SERVICE BULLETIN 20171122

720-4-CS Casting Change

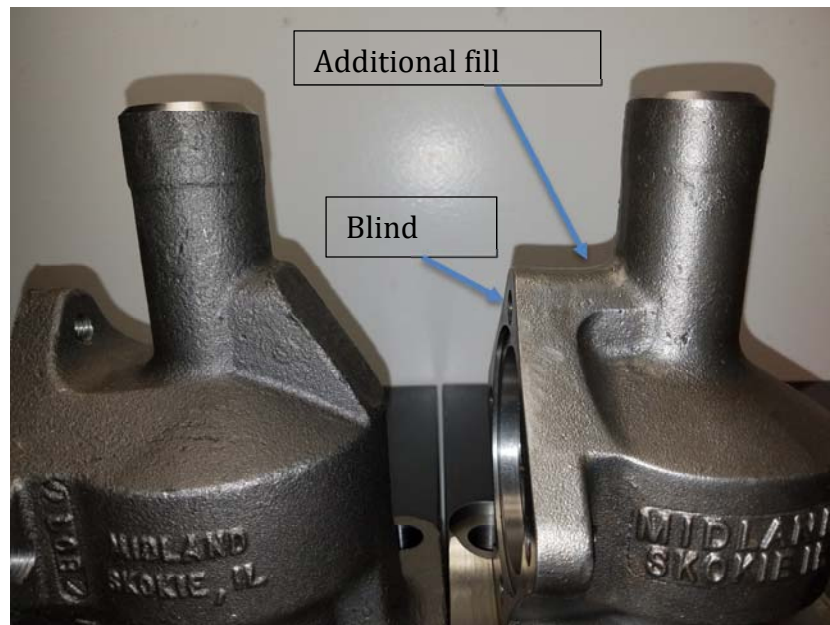
In order to reduce foundry scrap, Midland has added material as indicated below to the 720-4-CS valve body. The top flange bolt hole is now a blind hole. Now, there are two through and two blind holes to mount the flange. The flange bolts remain the same. Nothing else has changed on the body. The form, fit, and function remain the same. The bodies are interchangeable and will function the same.
